Groundwater and Wastewater Services File Imaging Project

PROPOSED PLOT PLAN

FILE: 5633 B

CONDITIONS OF IMPROVEMENT PERMIT

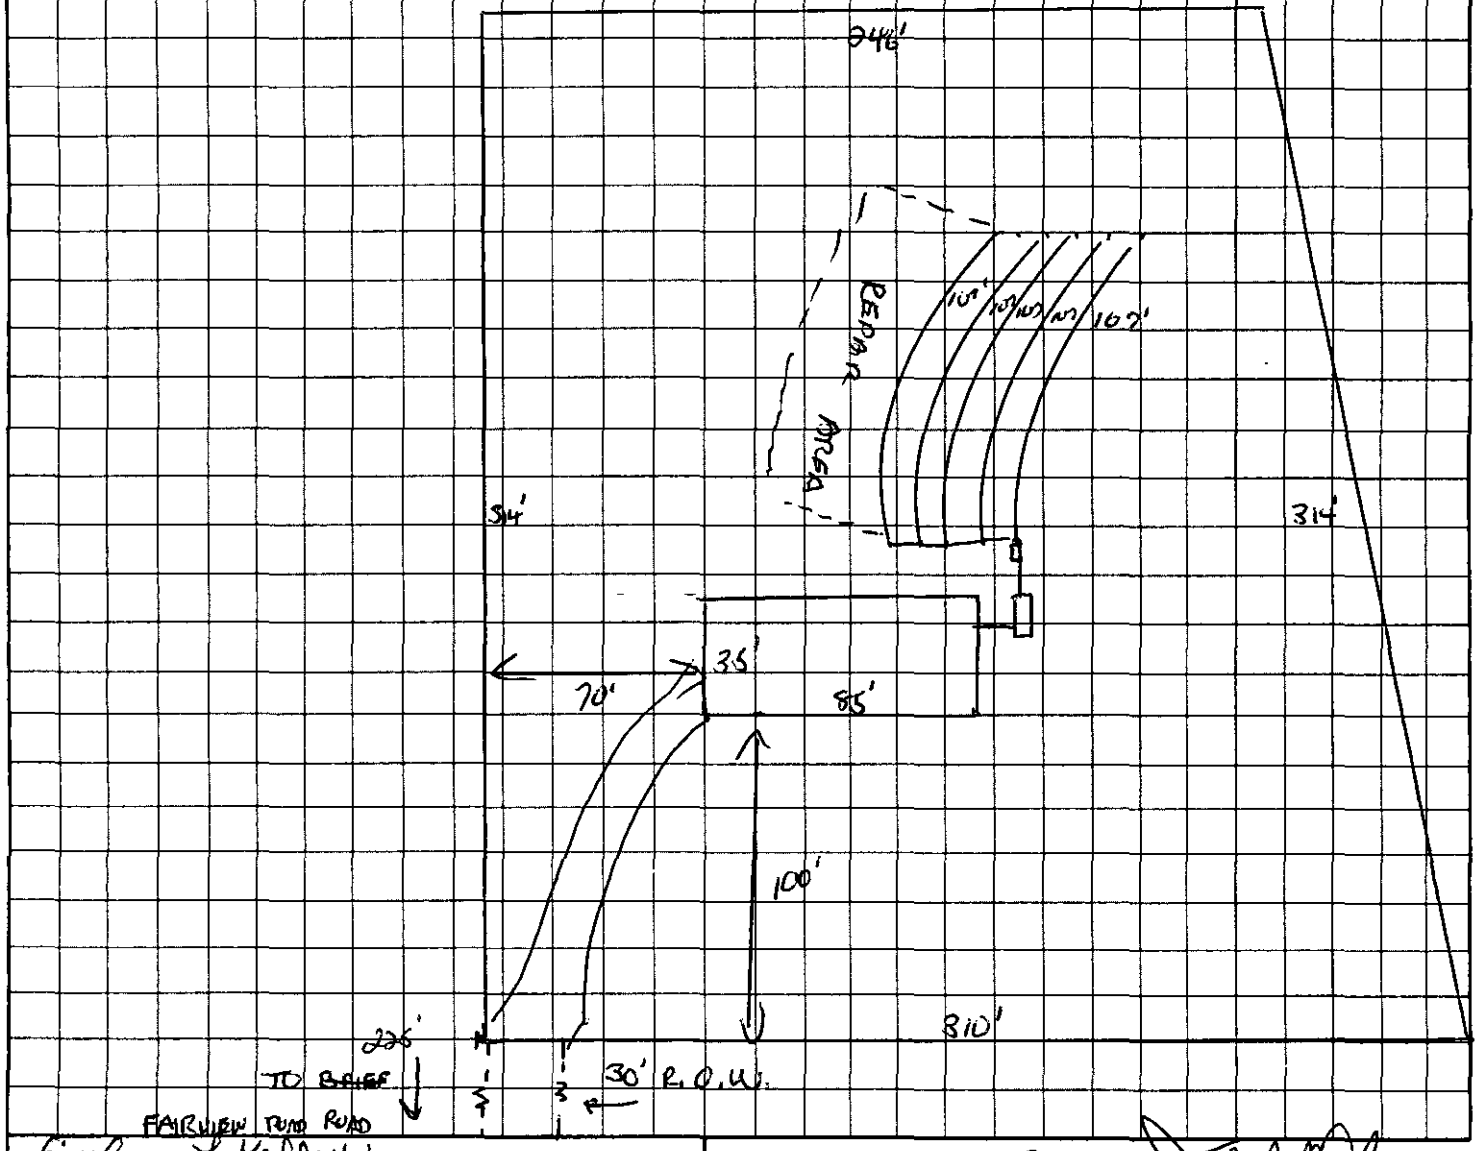
① LOCATE ALL WELLS 100' FROM ALL PARTS OF SEPTIC TANK SYSTEM, AT NO TIME LESS THAN 50'

② INSTALL DRAINLINES SHALLOW 30', AND ON CONTOUR.

PROPOSED PLOT PLAN

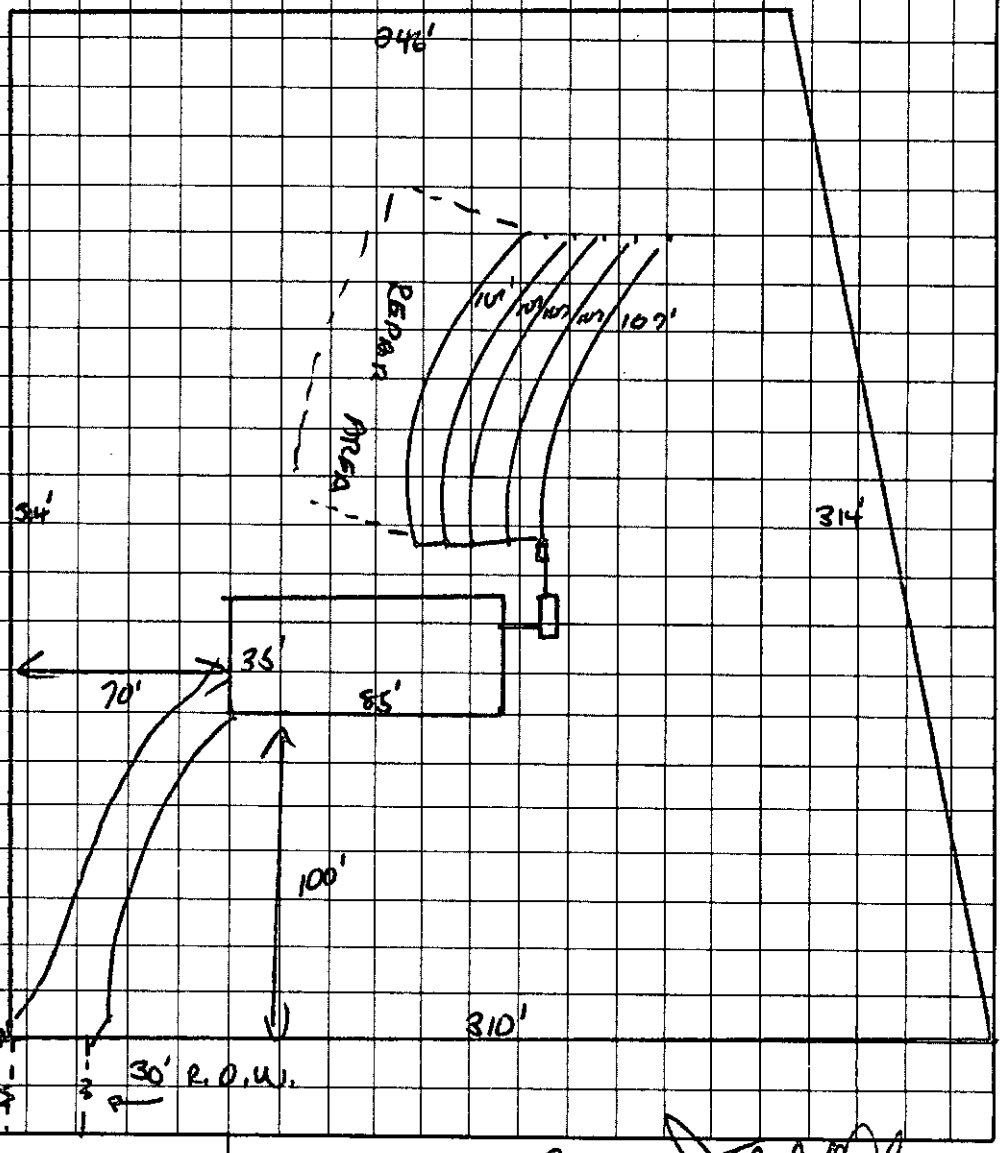
① LOCATE ALL WELLS 100' FROM ALL PARTS OF SEPTIC TANK SYSTEM, AT NO TIME LESS THAN 50'

② INSTALL DRAINLINES SHALLOW 36", AND ON CONTOUR
